Corrections of Hardware Manual

MB90570/A -

Addendum, MB90570/A Hardware Manual (CM-44-10102-7E)

This is the Addendum for the Hardware Manual CM-44-10102-7E of the MB90570/A microcontroller series. It describes all known discrepancies of the MB90570/A microcontroller series Hardware Manual.

Power-On Reset

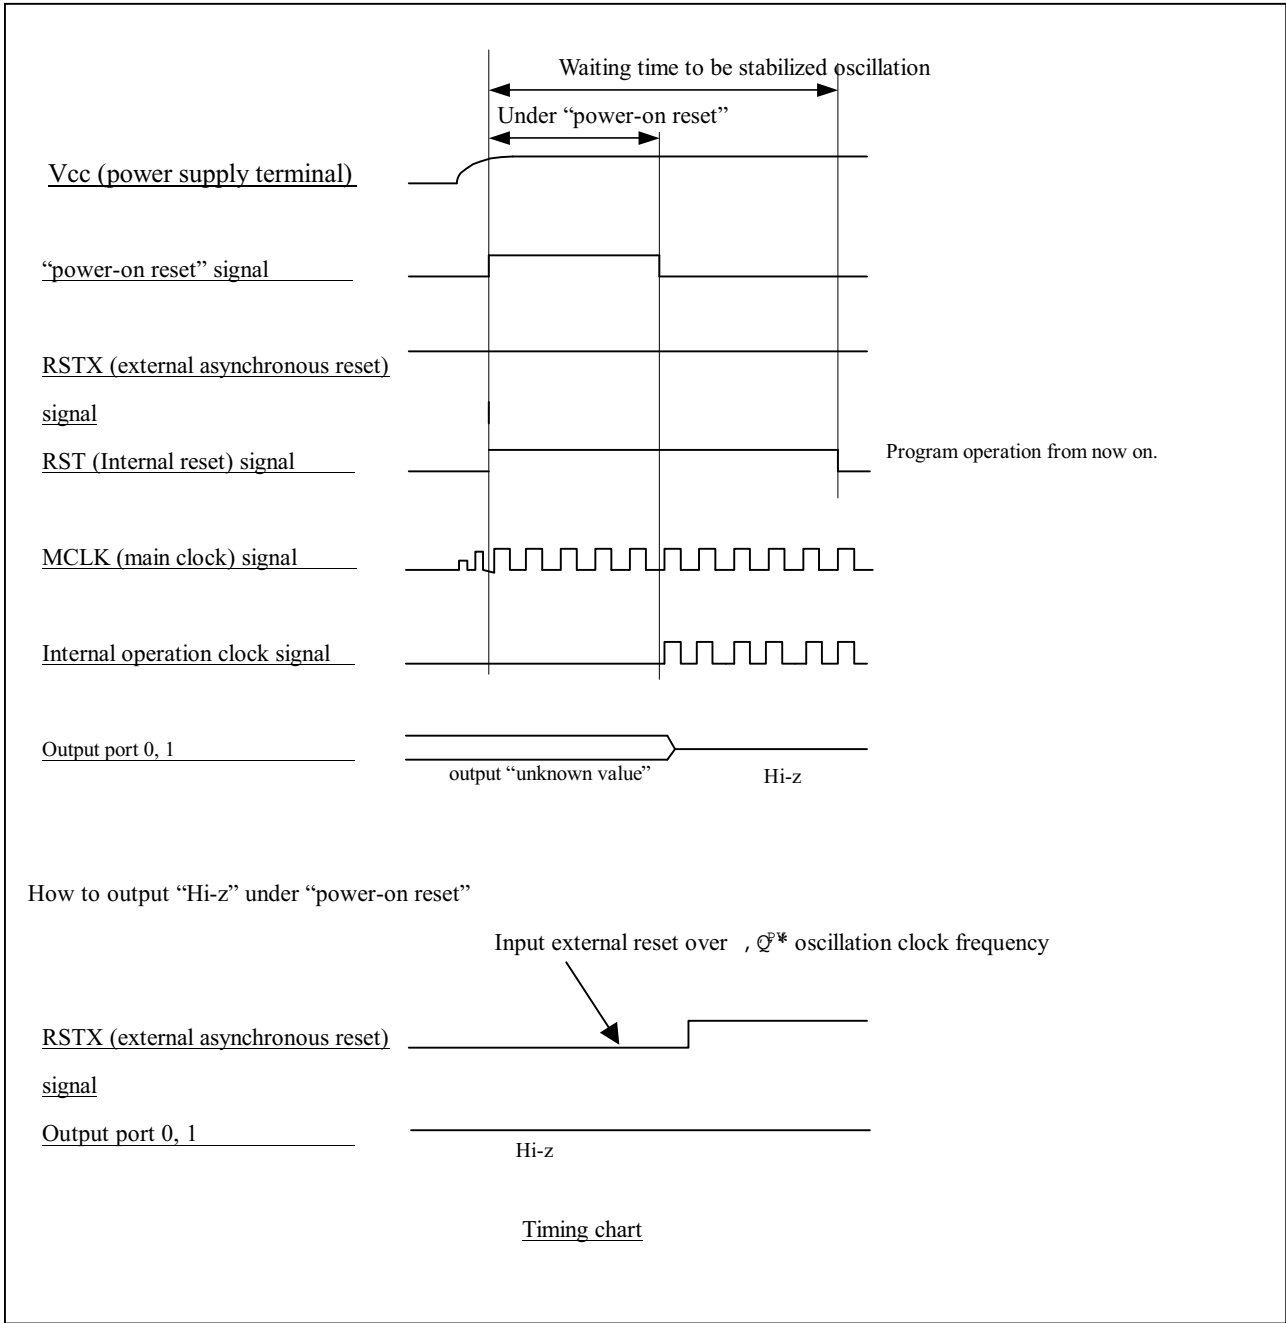
Output "unknown value" , when the power supply is turned on if F²MC-16LX is used. (Note)

Output "unknown value" of pin 00 to pin 7 and pin 10 to pin 17 terminal, when the power supply is turned on.

Pin 00 to pin 07 and pin 10 to pin 17 terminal become "unknown value" (output "H", "L" level or output "Hi-z") under "power-on reset" (stabilized times (2 * oscillation clock frequency) of clamping circuit for internal power supply), when the power supply is turned on, and when "power-on reset" function operates and RSTX terminal is "H" level.

If you want to output "Hi-z" under "power-on reset", it is applied reset input "L" level " from external and so pin 00 to pin 07 and pin 10 to pin 17 terminal become "Hi-z" condition during the time.

This workaround will work for Mode pin setting 011 (Single chip, Internal ROM external bus), 110 (Burn_In ROM), 111 (EPROM mode)
